(Defect Inspection) REPORT (hereinafter called the "Report")

Property Address: Sample drive

Slab
Frame
Lock-Up
Handover
Warranty

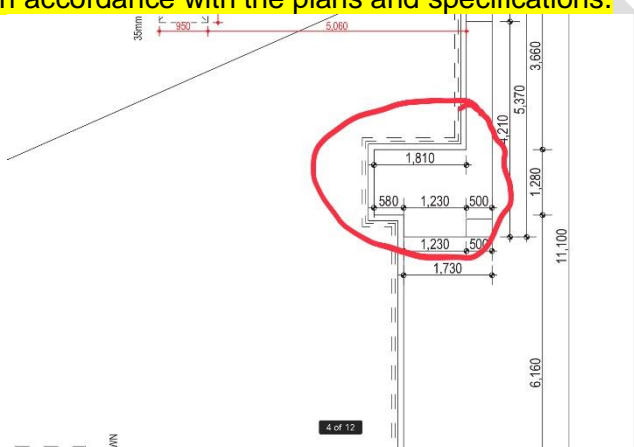
3. There are areas around the slab with concrete overpour.

Concrete overpour increases the effectiveness of the footing width and depth and decreases the bearing capacity required to support the external walls. This can result in lifted or more highly loaded areas. Concrete overpour below finished ground level allows water to accumulate on top of the footings and prevents normal evaporation drying of subsoil moisture. Concrete overpours can interfere with future site works or landscaping.

All footings in the NCC and AS 2870 are shown with edges of their footings vertical and without overspill. All excess concrete overpour from the house needs to be removed to allow the footing to work efficiently as designed.
